REAL ESTATE CHASE RE
DEVELOPMENT • CONSTRUCTION • FINANCE

7900 XERXES AVE S
Bloomington, MN

CONCEPT SITE PLAN

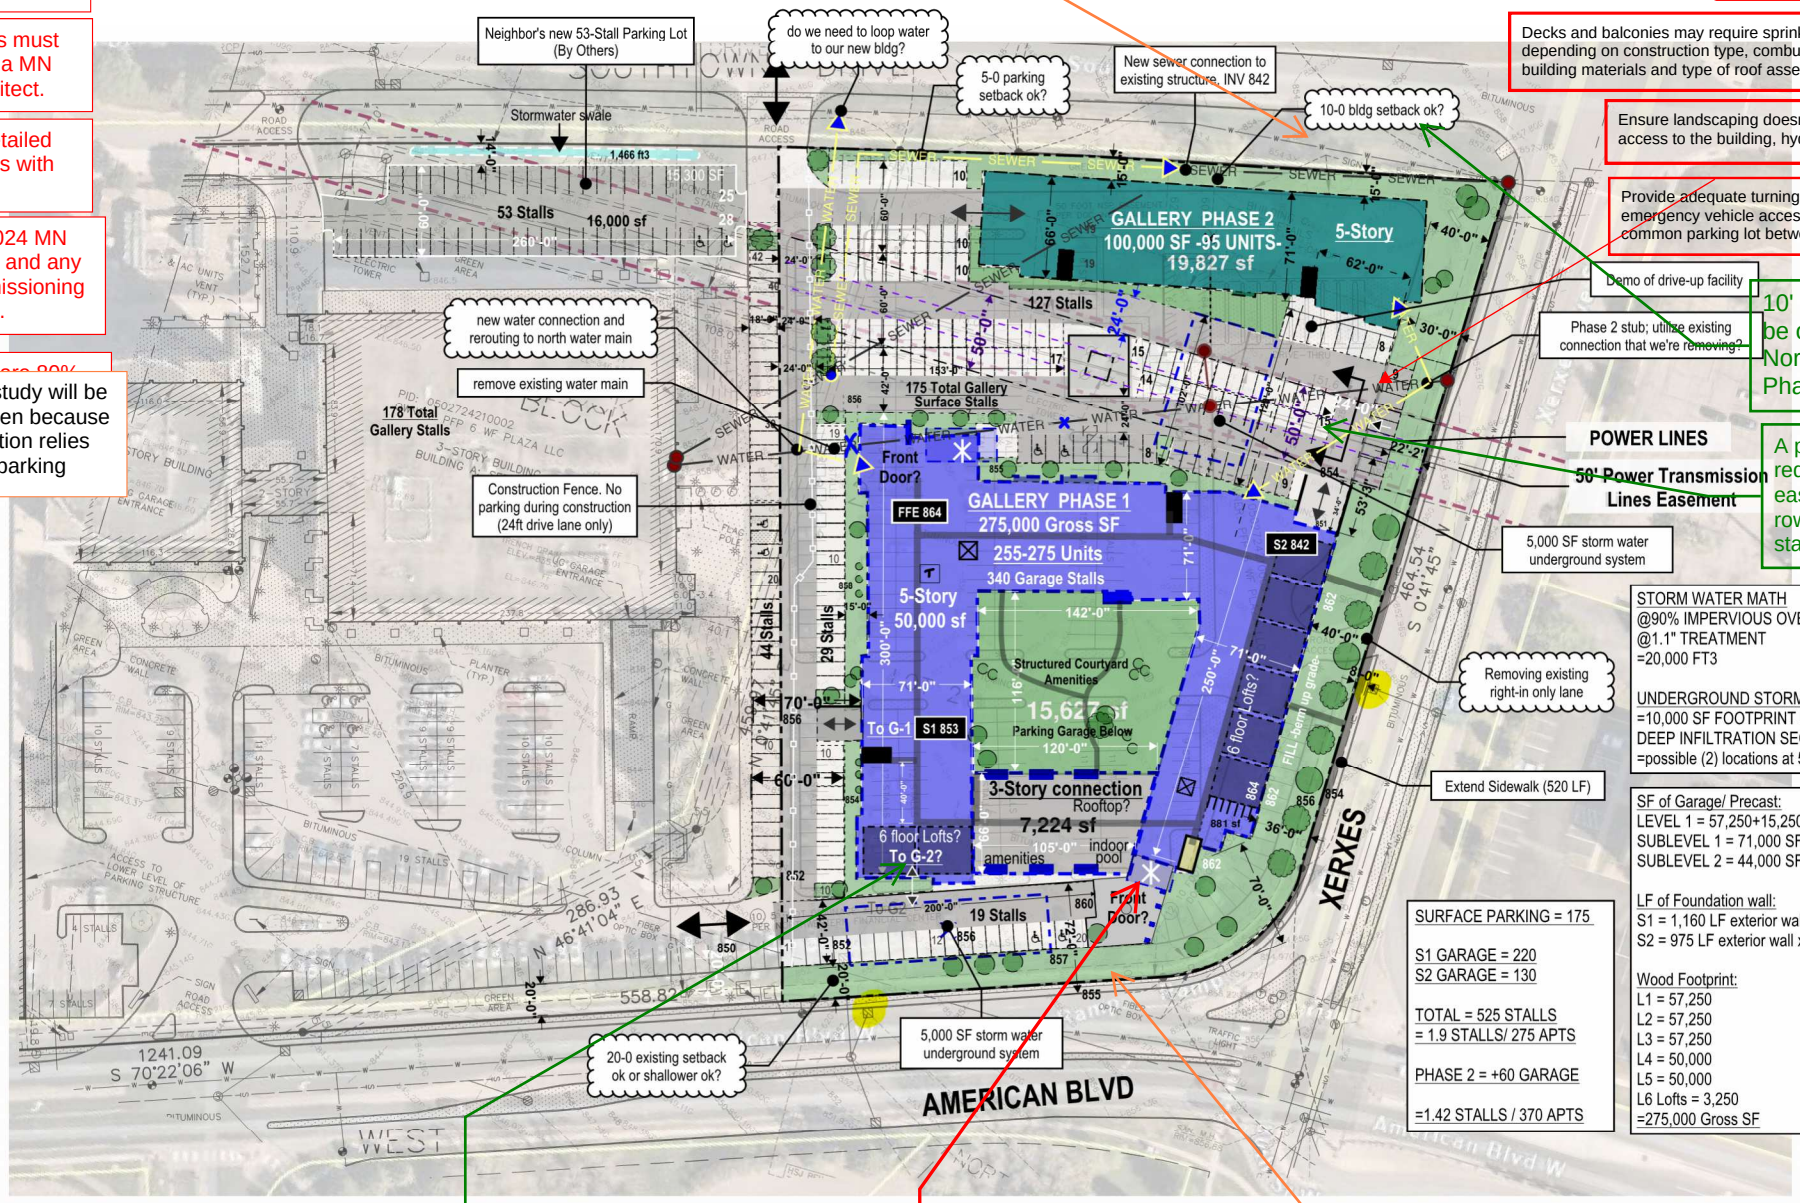
Include 6' sidewalk parallel to Southtown Drive

A looped water supply feeding a single, combined water service is required for the domestic and sprinkler system water demand. Solenoid devices are not to be used to meet sprinkler system demand.

Emergency responder radio coverage meeting the requirements of appendix P in the 2020 MSFC shall be provided throughout the property and within the structures.

Hydrant coverage shall be provided within 50' of the FDC and within 150' of all portions of the structure.

Decks and balconies may require sprinkler protection depending on construction type, combustibility of exterior building materials and type of roof assembly.

Ensure landscaping doesn't interfere with access to the building, hydrants and/or FDC.

Provide adequate turning radius for all emergency vehicle access lanes including the common parking lot between phase 1 & 2.

A parking study will be needed when because the application relies on shared parking

Can the garage be designed so that only one entrance is necessary on the western side?

Concerned with front door being at a dead end with limited access for emergency responders especially for medical response.

Include 8' sidewalk along American Bouelvard and Xerves Avenue

demonstrate how/where Metro Mobility and school buses will access/serve this site. Connect with Metro Transit and Bloomington Public Schools if there are questions about their access needs
